Modification of Development Consent

Modification 4

Modification Application: SSD-7016-Mod-4
Additions and alterations to the existing timber processing facility including reclamation of the remaining spring fed dam, relocation and expansion of the existing mechanic's workshop and improvements to the site's water treatment plant

Figure 1: Site Plan

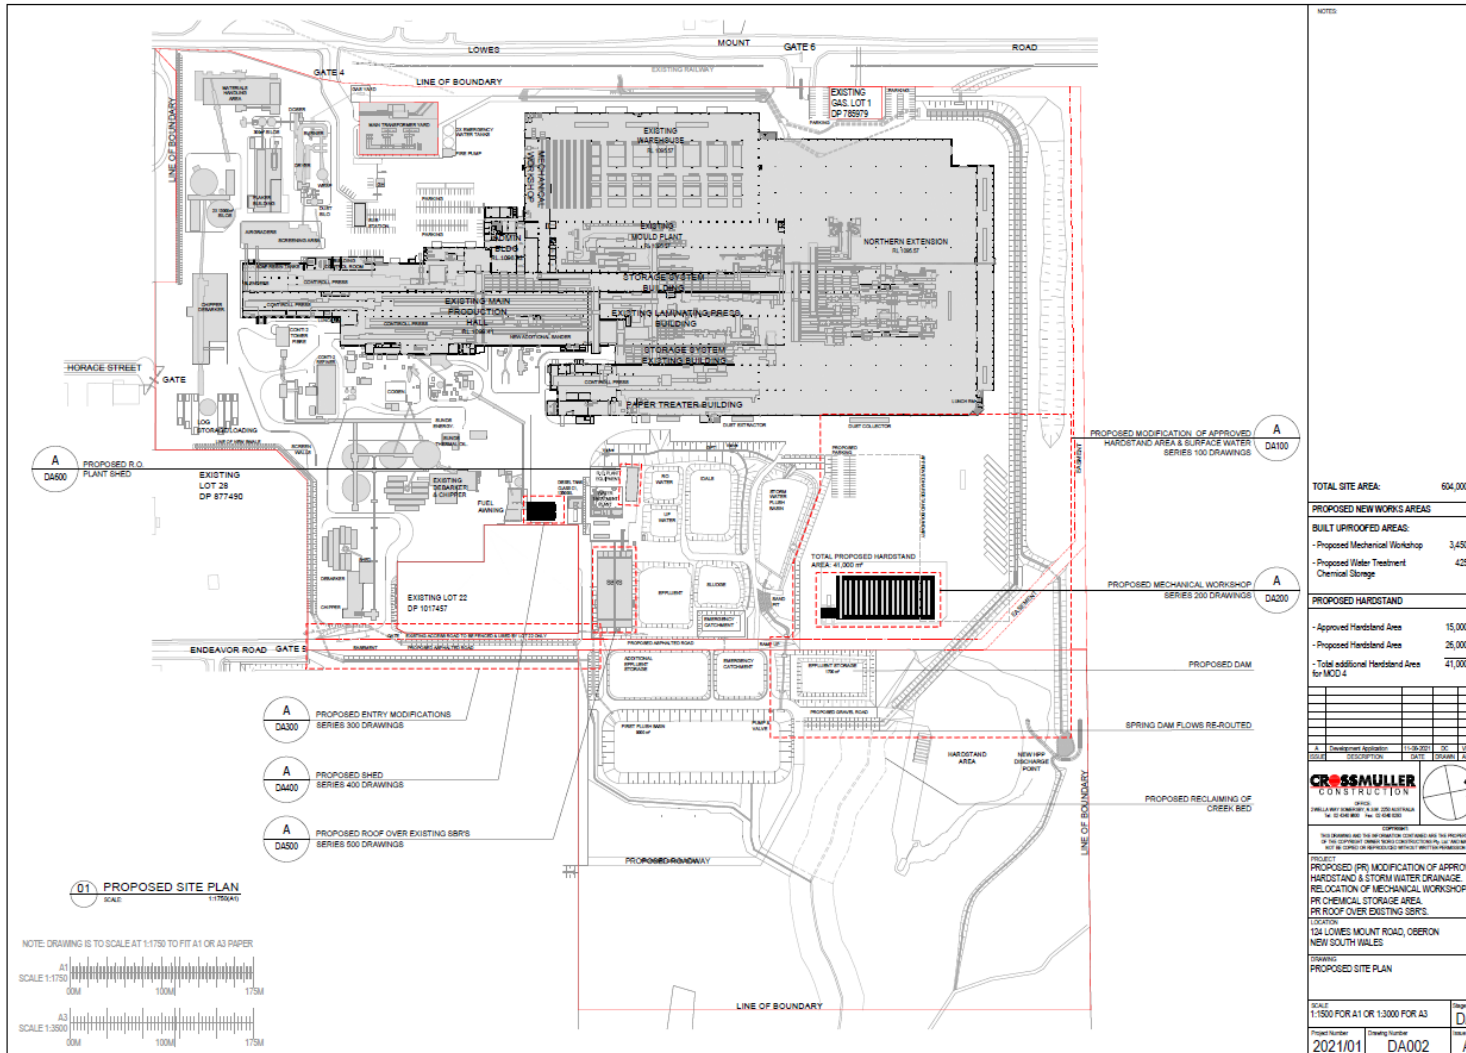
6. In Appendix A – Development Layout Plans, delete Figure 1 and replace with new Figure 1 as shown in Attachment A of this modifying instrument
